Onondaga County Planning Board

MEETING AGENDA

Wednesday, November 5, 2025

Case Number: S-25-37

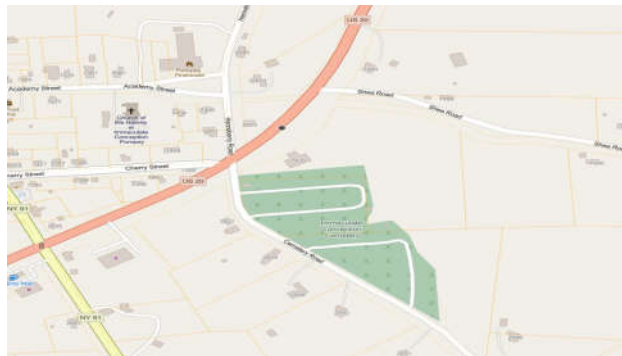
The applicant is proposing to subdivide a 10.15-acre parcel into two new lots, Lot 1 (5.010 acres) and Lot 2 (5.676 acres), in a Commercial © zoning district

Past Board Reviews:	The Board previously recommended Modification of site plan and area variance referrals (Z-16-262, Z-16-263) to construct a warehouse/office building, and the applicant must coordinate Route 20 access with the NYS Department of Transportation and coordinate with the Onondaga County Department of Health (OCHD) regarding any proposed septic system.
Concurrent Reviews:	The Board is concurrently reviewing a zone change referral (Z-25-322) to change the site to Residential (R) zoning to allow construction of a single-family home on proposed Lot 2.
Nearby Uses/Setting:	The site is located along the southeastern side of NYS Route 20, east of the area of Pompey. Small parcels containing residential and commercial uses are to the northwest and large parcels containing low-density residential, wooded areas, and agriculture occur to north, east, and south of the site.
Proposed Zoning:	Per the referral materials, the applicant is proposing a zone change on Proposed Lot 2 to Residential (R) to allow a single-family home to be constructed. Per the Town Code, the intent of the R District is "to provide for flexible patterns of family residential development that are protective of sensitive environmental features and resources; or to provide a transition between developed areas and farm and unique environmental areas; or to accommodate the preexisting pattern of one-acre lots and to continue to allow one-acre lot development when part of a planned approach." New lots within the R district are minimally 1 acre in size.

Wastewater:	The Dollar General is served by an individual septic system and no change is currently proposed. It appears the proposed single-family home will require a septic system.

Z-25-321

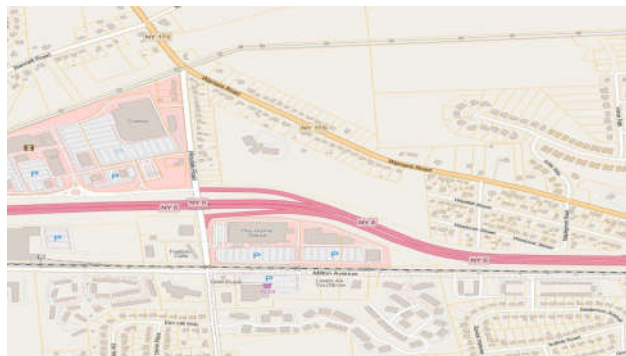
The applicant is proposing a zone change on six parcels totaling 22.14 acres from Limited Business Office (LBO) and Commercial (C-5) to Planned Unit Development zoning district, for the Church Street Station mixed-use development.

Proposed Site Layout: Per the Concept Site Plan B dated 10/8/25, the development will consist of buildings and parking lots arranged around a central public road. The road to Hinsdale Road across from a Township 5 right-in/right-out intersection all connects to Warners Road at the eastern side of the site between residential buildings. Two retail buildings totaling 7,000 sf with 8-space parking lots each will be located on either side of the internal road, along the Hinsdale Road frontage. Two residential buildings totaling 30,000 sf and parking lots containing 150 spaces are shown south of the church complex, with residential buildings located in the eastern portion of the site.

Per the Concept Site Plan B, the PUD will contain twelve 12-unit apartment buildings arranged along the southern site boundary. Townhouses will be arranged along the northern site boundary in six 6-unit buildings. Parking lots for the residential buildings will be located between the buildings and the public road. The townhomes may also have 4 to 6-car garages located adjacent to the parking lots. Per the Off Street Parking Data Chart on the Concept Site Plan B, the residential parking areas will provide 248 to 282 spaces, dependent on whether parking will be provided in a combination of open lot and garage spaces or open lot parking.

It appears from the Concept Site Plan B the church complex will be subdivided from the proposed development, but a proposed subdivision is not described in the referral materials.

Access: Changes from the previously referred zone change include the addition of two parcels along Hinsdale Road, depicted in the Concept Site Plan B as containing a stormwater facility. Additional changes include a reduction in parking from 300 spaces to 248-282 spaces, changing one townhouse building from a four-unit building to a six-unit building, and placing a traffic light and crosswalk at the intersection of the internal road and Hinsdale Road.

Stormwater: Per the Environmental Assessment Form (EAF) dated 7/15/25, 16.52 acres of the site will be disturbed by the proposed project. Per the Concept Site Plan B, stormwater will be located between residential buildings and the northern and southern boundaries and stormwater basins will be located in the southeast corner of the site and along Hinsdale Road. Per the EAF, the development will result in the loss of 16 acres of forest and 7 acres of meadows, grasslands or brushlands.

Z-25-327

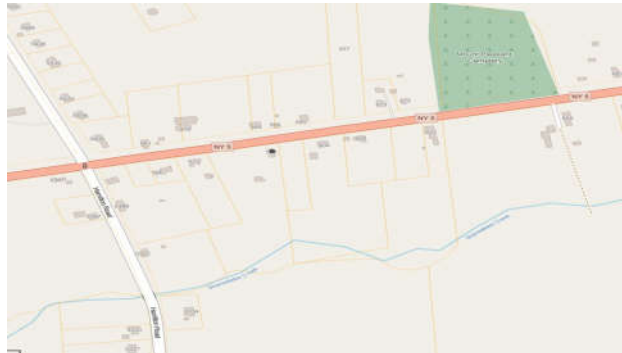
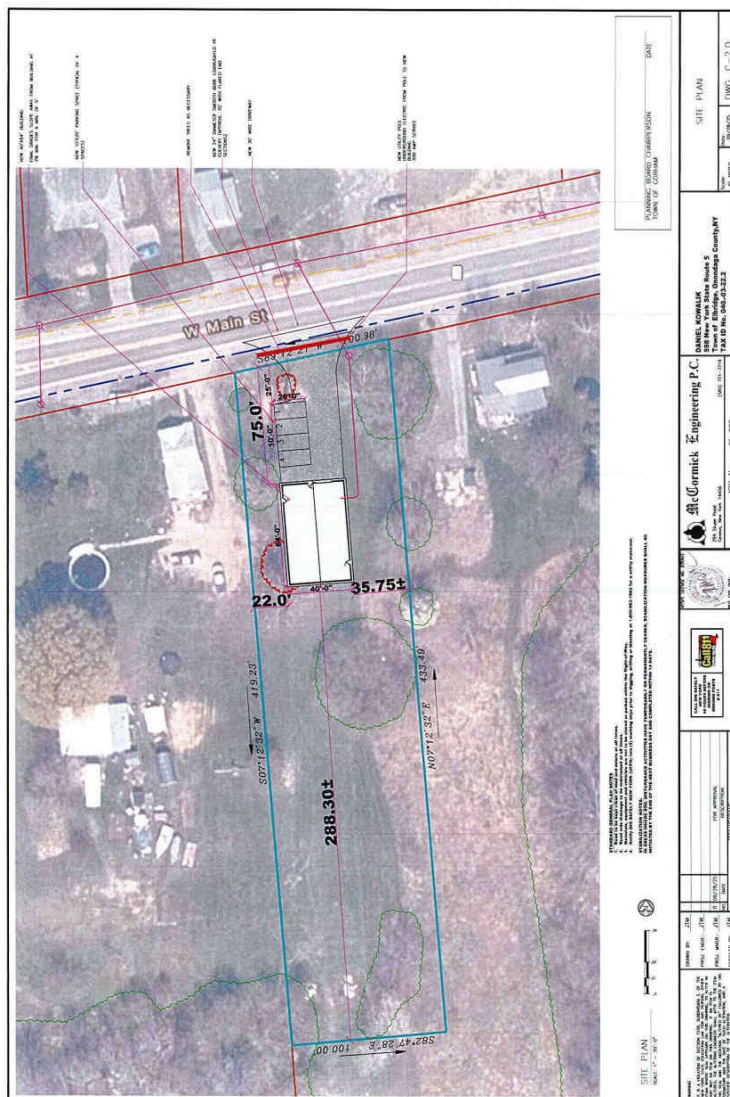
the applicant is proposing construction of a 2,560 sf post frame cold storage building on a vacant 1.02-acre parcel in a Business (B-1) zoning district

Nearby Uses/Setting:	The site is located along the south side of NYS Route 5 in the Town of Elbridge west of its boundary with the Village of Elbridge. The area is characterized by density residential and large parcels containing agriculture and/or woodland. Residential lots abut the site on either side. Skaneateles Creek is located to the east of the site, not on the subject parcel.
Existing Site Layout:	Per aerial imagery from May 2024, the site is vacant, containing lawn and trees.
Proposed Site Layout:	Per the referral notice, the applicant is proposing construction of a 40'x64'x10' (2,560 sf) cold storage building. Per the Site Plan dated 9/28/25, the building is positioned in the center of the parcel's road frontage with four parking spaces on the side of a proposed 30'-wide driveway to Route 5.
Access:	The site has no current access to NYS Route 5. Per the Site Plan, the applicant is proposing installation of a new culvert and 30'-wide driveway to Route 5. ADVISORY NOTE: Per the NYS Department of Transportation, all existing and proposed driveways on NYS Route 5 must meet Department requirements.

Drinking Water:	Per the referral materials, there is no existing drinking water service to the site. No changes to the existing infrastructure are proposed.
Wastewater:	Per the referral materials, there is no existing wastewater service to the site. No changes to the existing infrastructure are proposed.
Watersheds:	The site is located over, or immediately adjoining, a principal aquifer (per EAF Mapper).
Historic Resources:	The site or a portion of it is located in or adjacent to an area designated as a historic site for archaeological sites on the NYS Historic Preservation Office archaeological inventory (per EAF Mapper). ADVISORY NOTE: The applicant and/or municipality is advised to contact the Historic Preservation Office to determine if the project should be submitted to the Historic Preservation Office for review as part of the State Environmental Quality Review (SEQR) process.
Stormwater:	Per the Environmental Assessment Form (EAF) dated 10/23/25, the new building will not generate any additional stormwater.

Z-25-328. 329

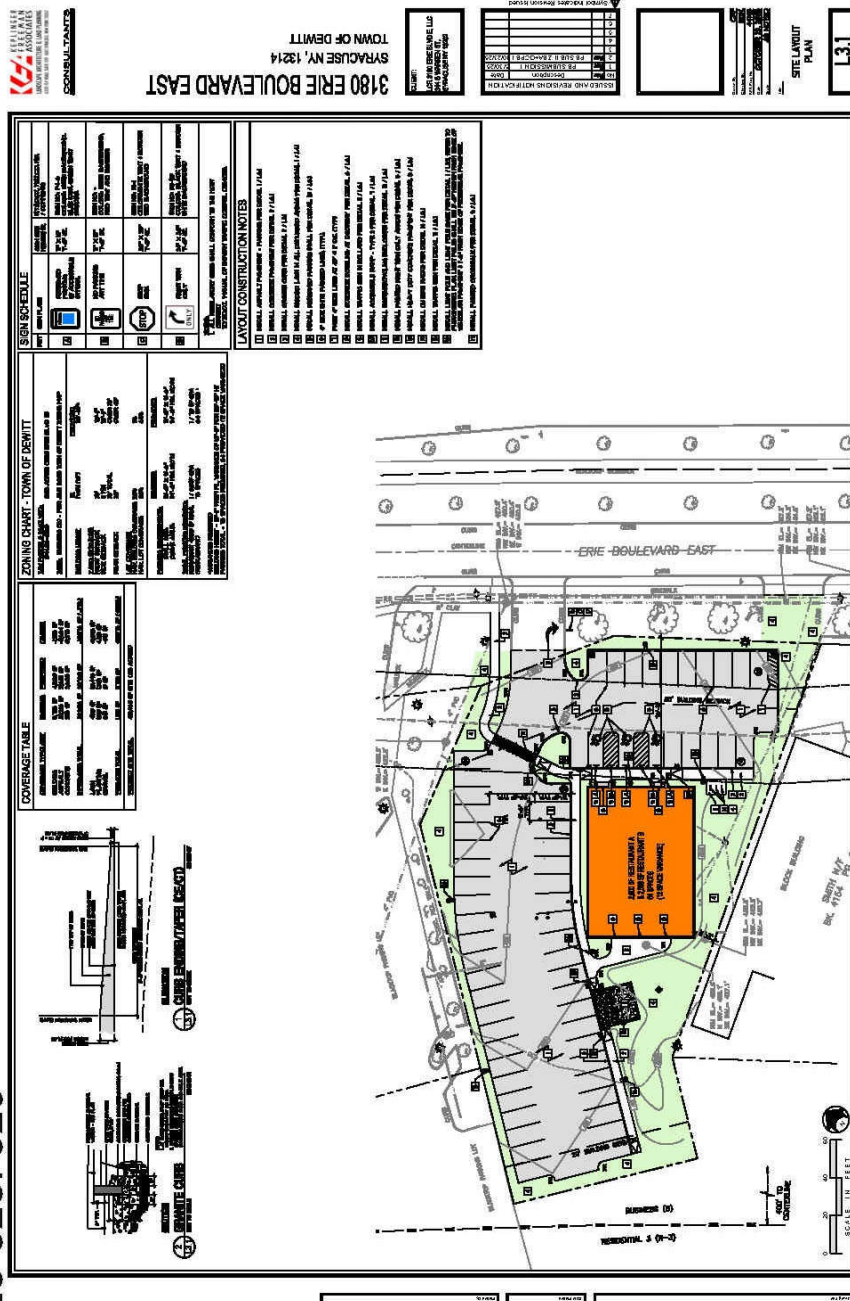
Proposed Site Layout:	Per the referral materials, the applicant is proposing demolition of the existing building and construction of a new 4,500 sf building to house two restaurants along with reconstruction of the parking lot and adding landscaping. Per the Site Layout Plan dated 10/23/25, the proposed building will be positioned in approximately the same location as the existing restaurant with a 64-space parking lot located on the northern and eastern sides of the building. A dumpster enclosure will be located to the rear of the restaurant building. Sidewalks will be installed along the parking lot and will connect to sidewalks along the Erie Boulevard East.
Variances:	The applicant is requesting two area variances: to allow the proposed building to be 20'10" high when Town Code limits the building to 10'2" ("one foot vertically and one foot horizontally, until the horizontal distance is greater than or equal to 10 feet" per Town Code) and to allow the proposed 64-space parking lot when 48 spaces are required by Code.

Access:	The site has two existing driveways to Erie Boulevard East along with a possible cross connection to Erie Boulevard East via an adjacent parcel to the south. Per the Site Layout Plan dated 10/23/25, the southern driveway to Erie Boulevard East and the cross connection will be closed, leaving one driveway to Erie Boulevard East. ADVISORY NOTE: Per the NYS Department of Transportation, all existing and proposed driveways on Erie Boulevard East must meet Department requirements.
Lighting:	A Site Photometric Plan dated 10/23/25 was included with the referral materials.
Landscaping:	Per a Site Planting Plan dated 10/23/25, five trees will be installed adjacent to the parking lot and shrubbery and plantings will be installed around the building.

Stormwater: Per the Environmental Assessment Form (EAF) dated 9/9/25, 0.67 acres of land will be disturbed by the proposed project and stormwater will be directed to "municipal system from on site structures." Per the Site Plan, it appears the proposed changes to the site will result in significant areas currently covered by asphalt converted to lawn.
